e-Callisto Non Conformance Report (NCR)

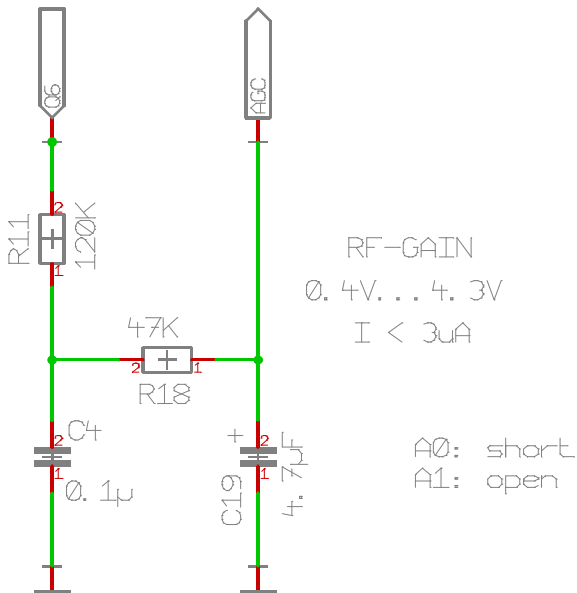
In view of automatic quality control, it was foreseen to measure the applied control voltage of tuner (AGC). This voltage is produced by PWM via bit Q6 from the RISC processor. In theory the maximum AGC voltage can be up to 4.3 volts. Since the internal reference voltage of the ADC is only 2.5 volts, it is not possible to measure AGC voltages higher than 2.5 volts. This was never tested; therefore the log file entry about AGC voltage is wrong if it should be higher than 2.5V.

If the PCB should be redesigned in the future, then one should take into account a high impedance voltage divider (>1 Mohm) for AGC voltage which is fed into an ADC. This design error has no influence to the spectrometer function.

Decision: use PCB as it is, no redesign at then moment.
